RE: CC Docket Nos. 96-45 and 97-160

The HAI model is fundamentally flawed

Hatfield's Polygons Converted to Rectangles

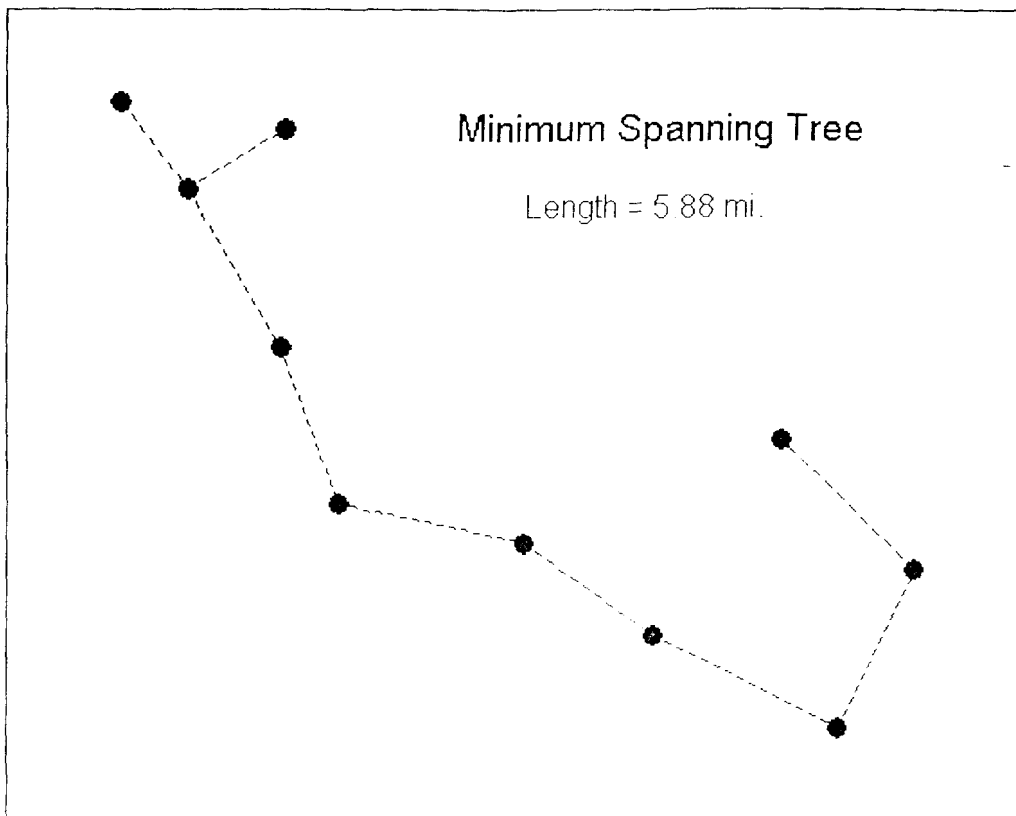
We have determined that the *minimum spanning tree* for these points – the mathematically shortest connection possible for these points – is 5.88 miles.

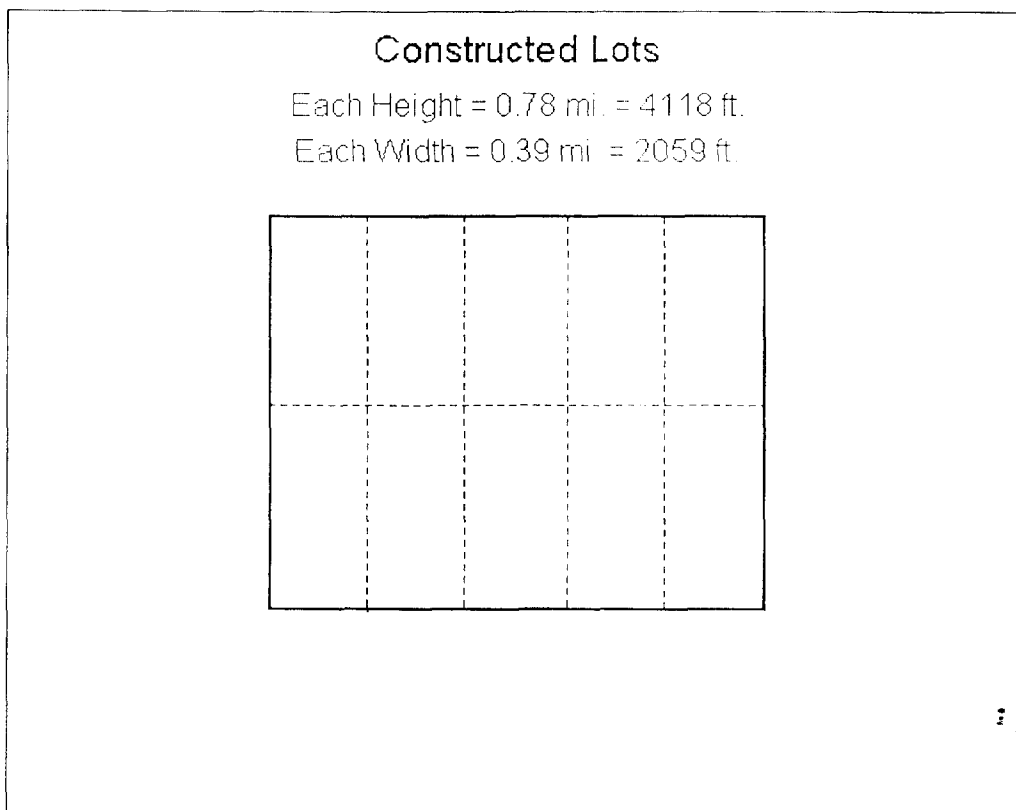
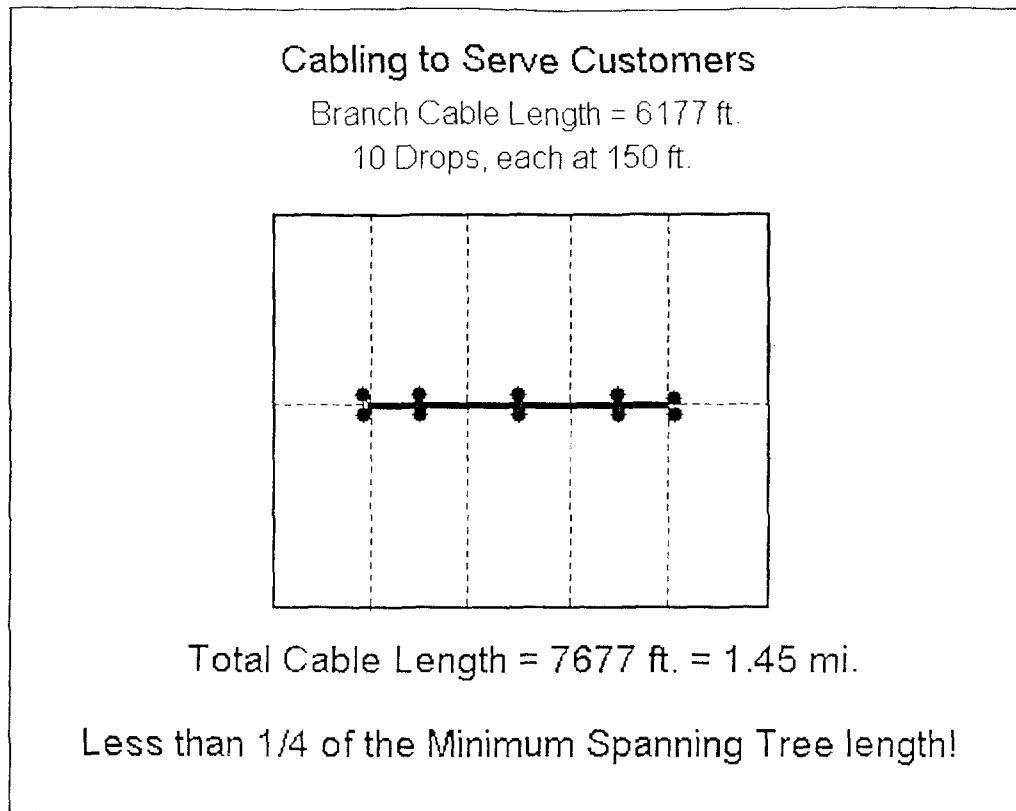
A *branch cable* is then constructed, and 150 ft. drops connect to the customers.

But note how closely the customers are squeezed toward the branch cable. The arrangement is unrealistic, both from the standpoint of cable length *and* from the standpoint of area served.

Customer Area Served

Height = 300 ft.

Width = $106 + 6177 + 106$ ft. = 6389 ft.

Area Served = 1,916,700 sq. ft. = 0.0688 sq. mi.

But Actual Cluster Area = 3.07 sq. mi.

Area Modeled is 1/44 of Cluster Area
